UNITED STATES  
NUCLEAR REGULATORY COMMISSION

SUBJECT: REQUEST FOR ADDITIONAL INFORMATION (RAI) REGARDING THE SIMPLIFIED  
BOILING WATER REACTOR (SBWR) DESIGN (Q220.1-Q220.57)

REQUEST FOR ADDITIONAL INFORMATION (RAI) ON THE  
SIMPLIFIED BOILING WATER REACTOR (SBWR) DESIGN

Civil/Structural Engineering Design

STABILITY CURVES FOR AXIALLY LOADED COMPRESSION MEMBERS

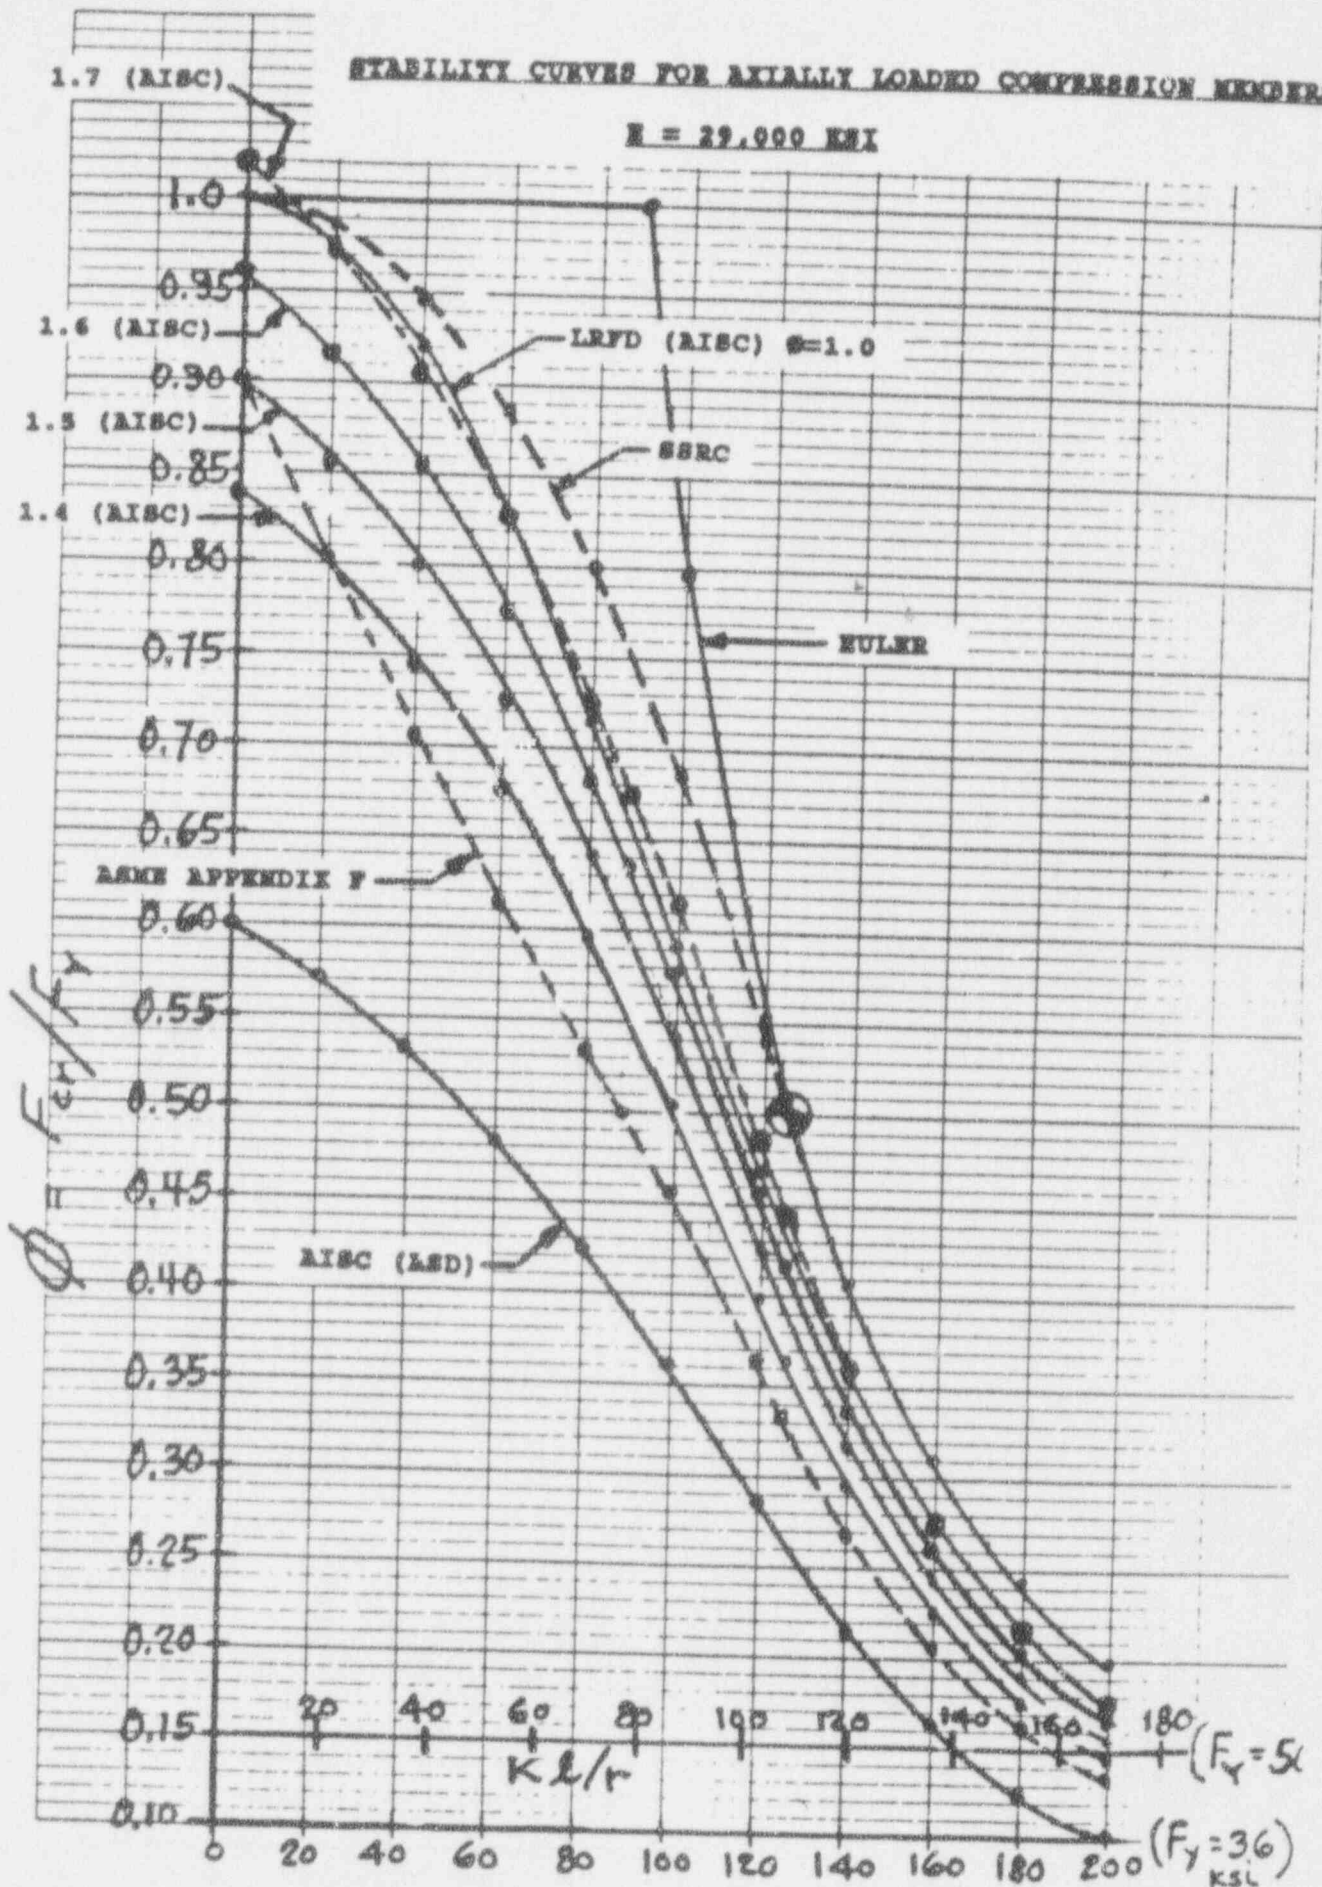
3. The research done in the last twelve years on the strength and stability of compression members indicates that the base curve (SSRC curve in Figure 1) used in arriving at the stress limit coefficients (SLCs) in SRP Sections 3.8.3, 3.8.4, and in the Standard does not reflect the results of the available test data. In developing the AISC Building Specification based on Load and Resistance Factor Design (LRFD) concept, the AISC changed the formulation for compression members to reflect the results of the test data. The LRFD curve (with  $\phi=1.0$ ) is also shown in Figure 1. Based on the test-data, this curve has the minimum reliability index,  $\beta^*$  of 2.6 (Ref. 1). The LRFD specification requires  $\phi=0.85$  in establishing the resistance of compression members.

Figure 1 shows the curves reflecting the SLCs of 1.0, 1.4, 1.5, 1.6 and 1.7 as applied to the stresses specified for allowable stress design (ASD) of the AISC. Based on the comparison with the LRFD curve ( $\phi=1.0$ ), the following SLCs are recommended in the interim position:

SLC of 1.6 ( $\phi=0.95$ ) for load combinations 10 and 11. This is reasonable for load combinations containing the effects of the two low probability events, i.e., SSE+LOCA.

SLC of 1.4 ( $\phi=0.84$ ) for load combinations 7, 8 and 9. This is appropriate for combinations containing the effects of the single low probability events, i.e., SSE, Tornado or LOCA.

SLC of 1.3 in load combinations 2, 5 and 6 is recommended when the secondary stresses due to  $T_o$  are included in the load combinations. This is consistent with the current position of allowing higher stresses under the effects of operating temperature.
